SUBJECT: Response to City Geotechnical Review for MA22123, Proposed New Warehouse/Retail Facility, Riverside Drive (APN 156-030-016, -017 and -042), City of Jurupa Valley, California

Introduction/Items Response

As requested, we have prepared the following response to the subject review comments dated April 7, 2023.

NEW WAREHOUSE/RETAIL FACILITY SITE PLAN PROJECT No. MA22123, SDRP22038

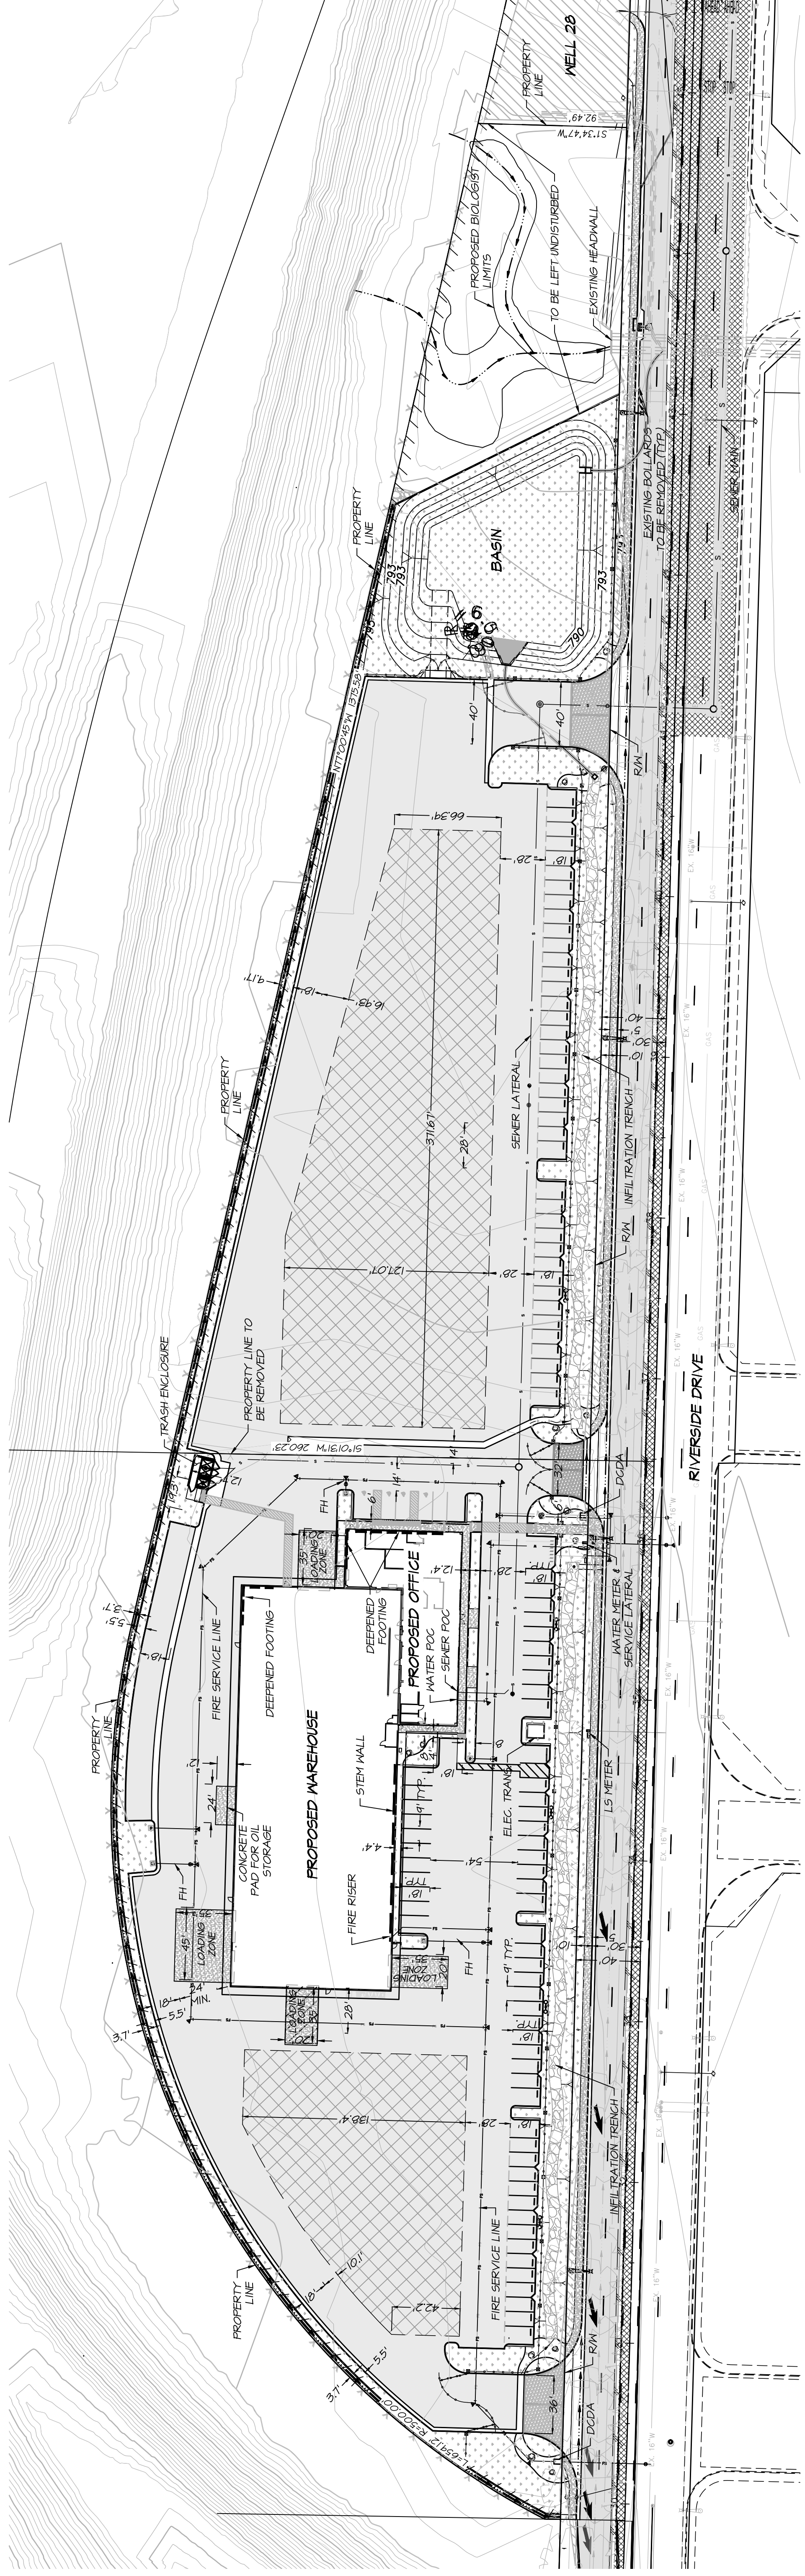
Comment No. 1: Rodriguez Consulting and Engineering is new geotechnical consultant of record for the subject site. After reviewing the above referenced report, the updated site plan (dated 5/23/2023), conceptual gradings (See Attachments), all pertinent geology maps for the area (including geologic hazard maps), we have come to the conclusion that the latest proposed development, the existing site condition, the scope of work and geologic hazards are remain the same. Recommendations presented in the previous reports and additional recommendations based on our observations/testing of any site grading and inspection of foundation excavations will be followed during construction. The current grading plans will be reviewed for conformance with the report. Rodriguez consulting and Engineering should review any changes in the project and modify and approve in writing the conclusions and recommendations of this report.

CITY OF JURUPA VALLEY CONCEPTUAL GRADING PLANS RIVERSIDE DRIVE & WINEVILLE ROAD NEW LIGHT INDUSTRIAL BUILDING/RETAIL FACILITY TITLE SHEET ACCT. NO. SHEET 1 OF 4 CITY I. D. NO. PLOT TIME: 5/9/2023 9:13 AM

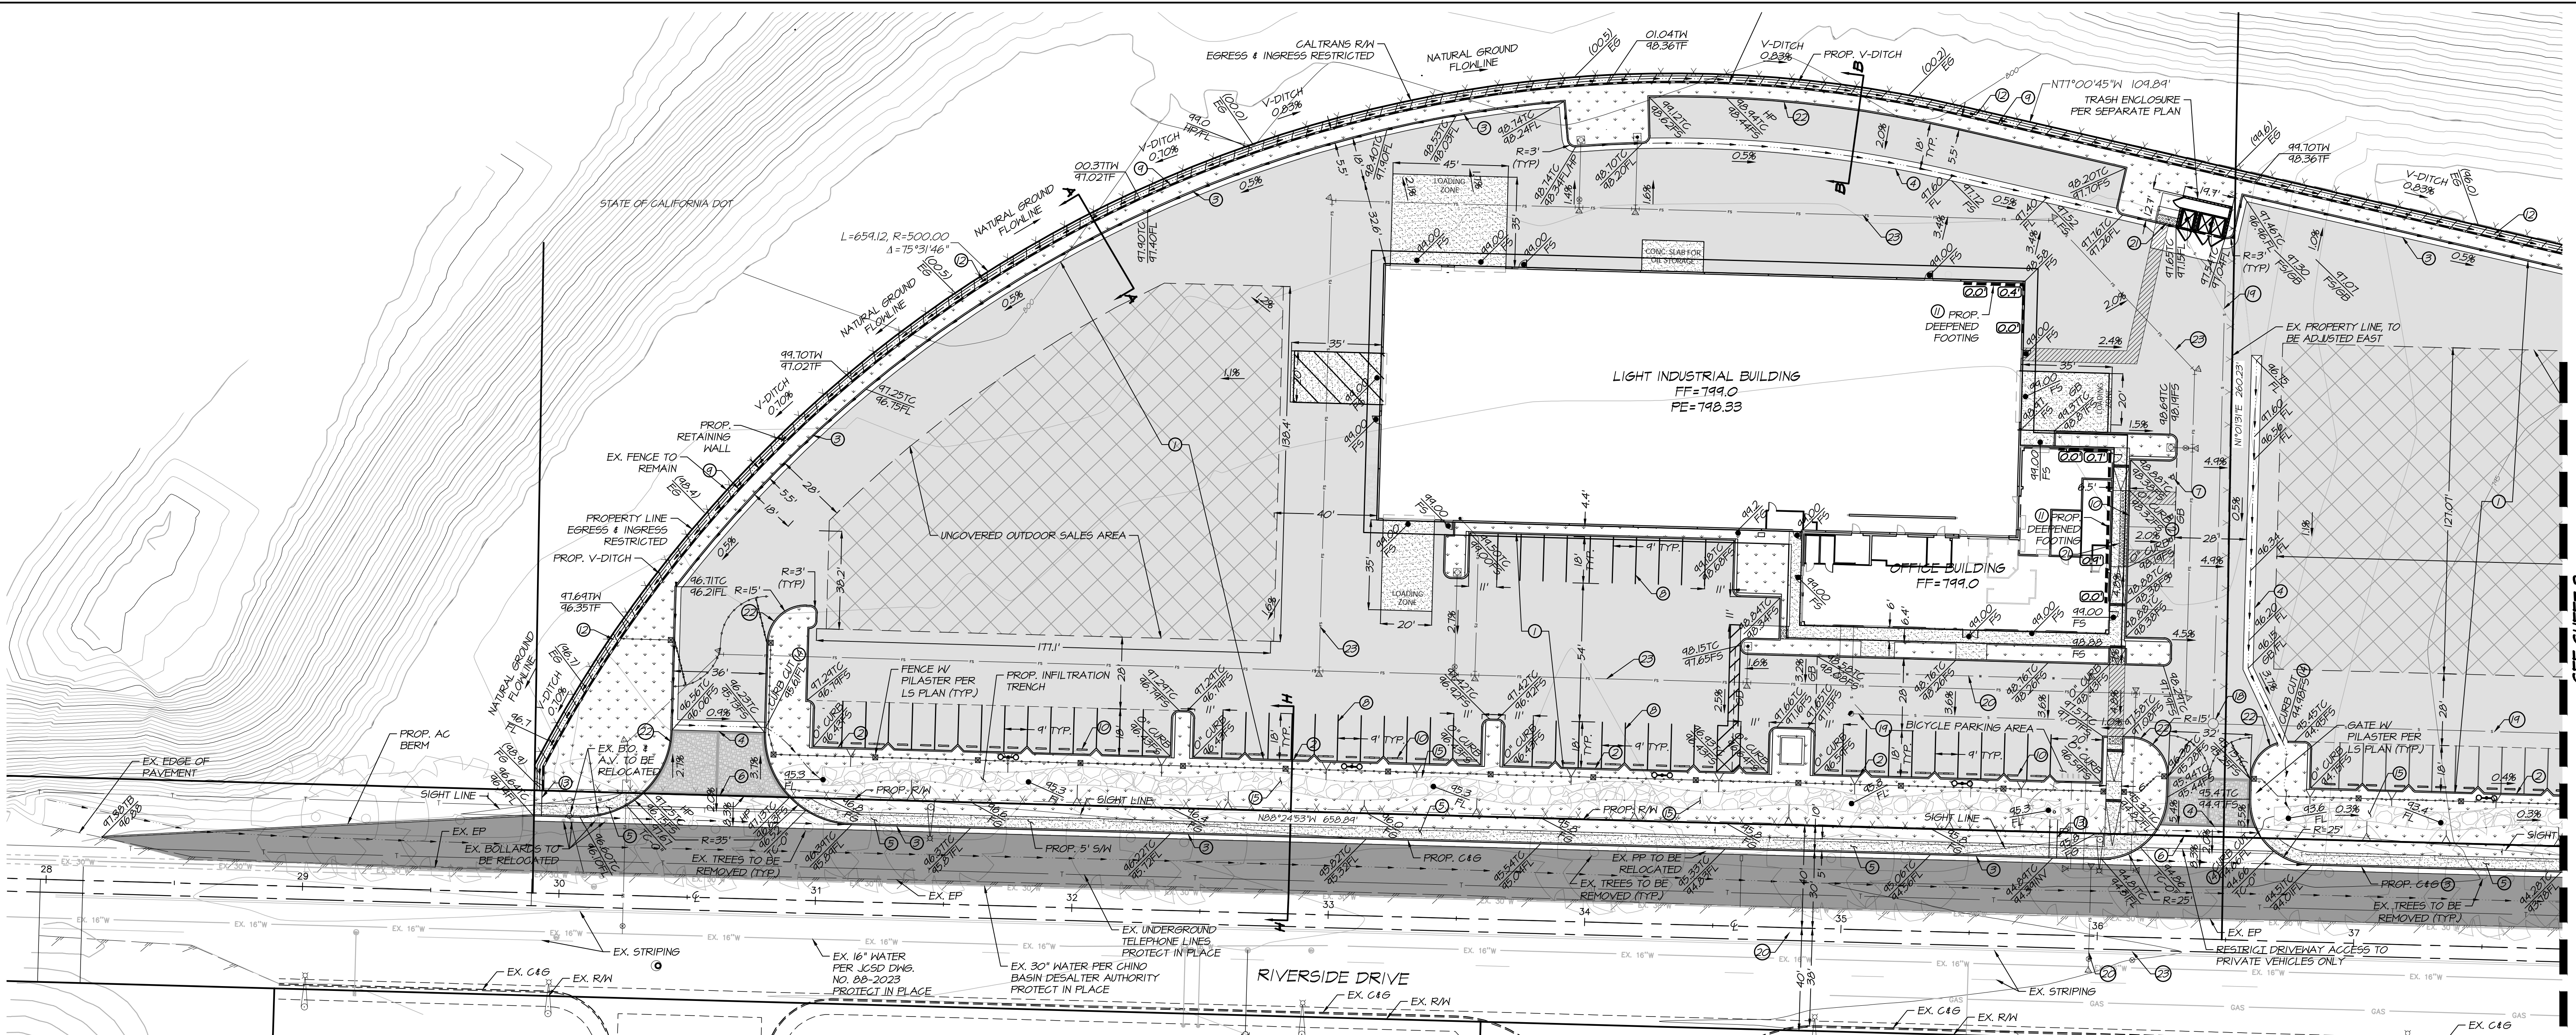
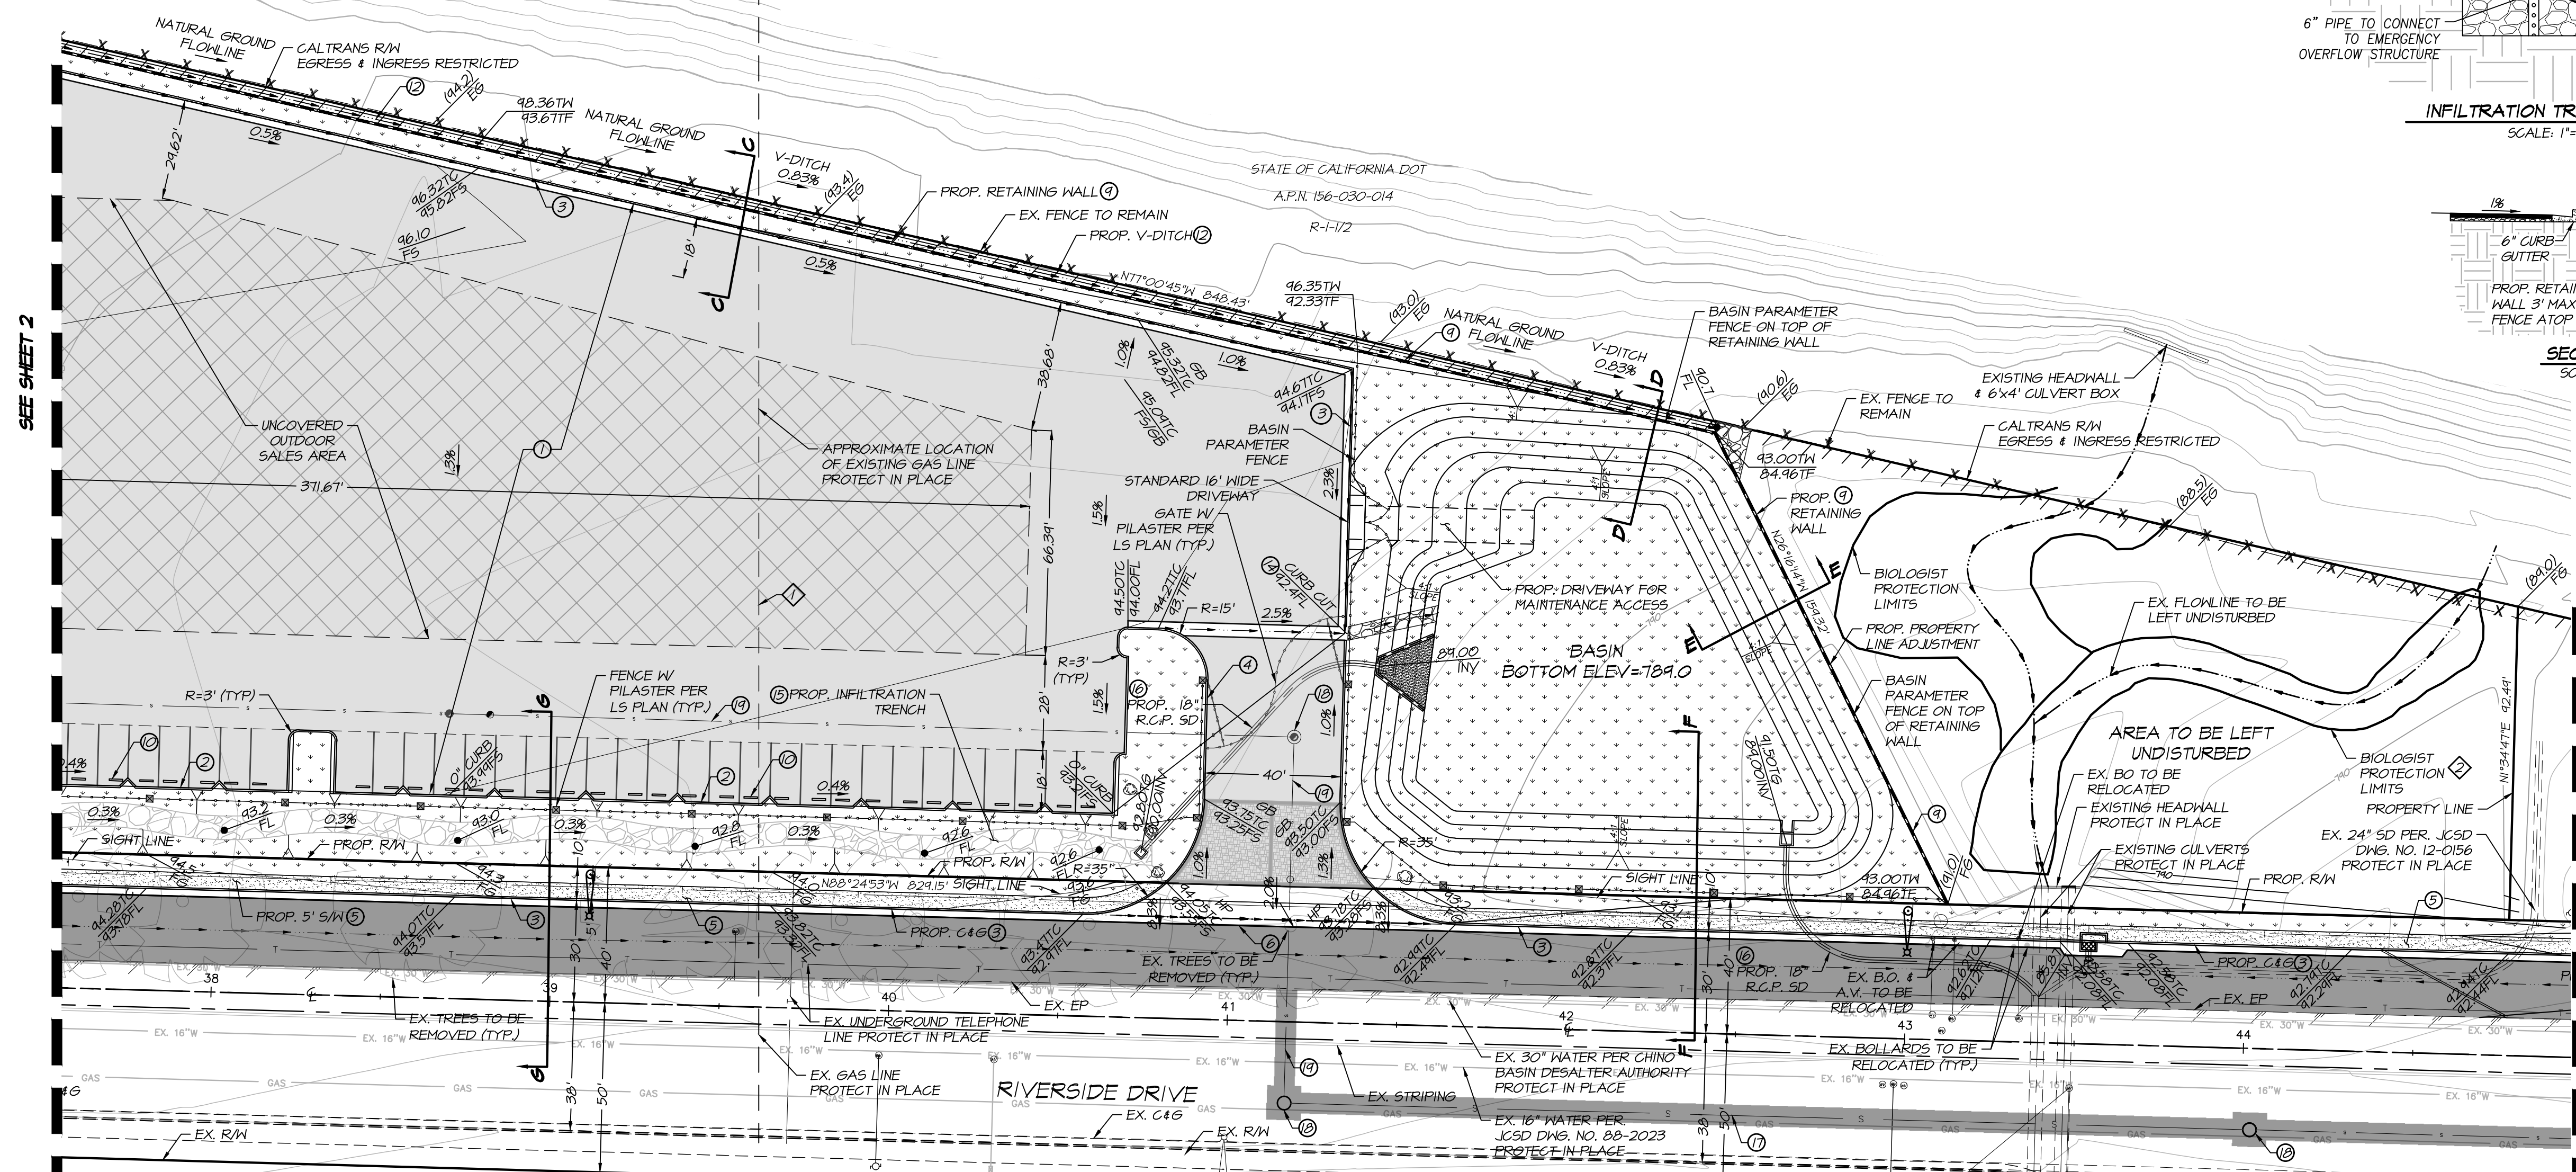
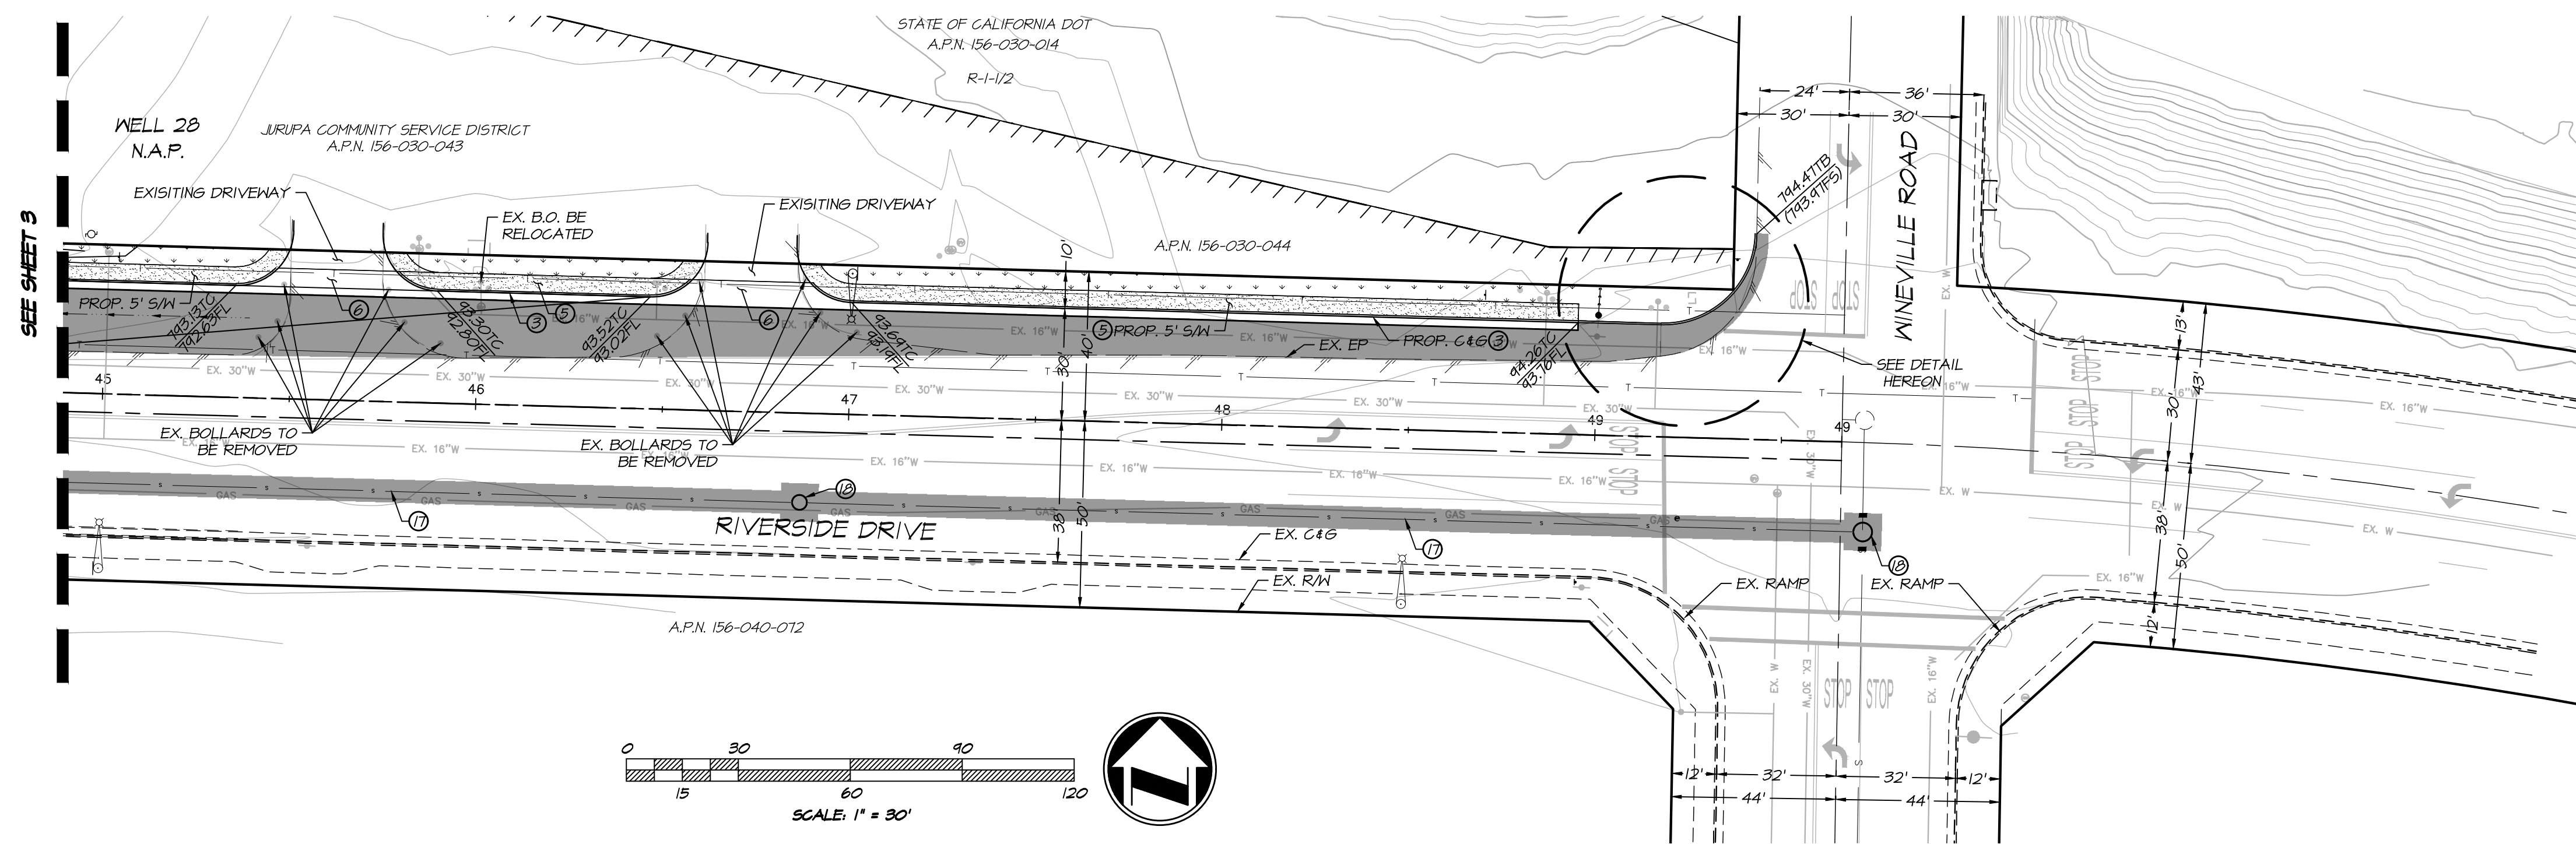
Comment No. 8: The conceptual grading plans that were submitted to the City were reviewed and the future precise grading plans and foundation plans will be reviewed for conformance with the report. Rodriguez consulting and Engineering should review any changes in the project and modify and approve in writing the conclusions and recommendations of this report.
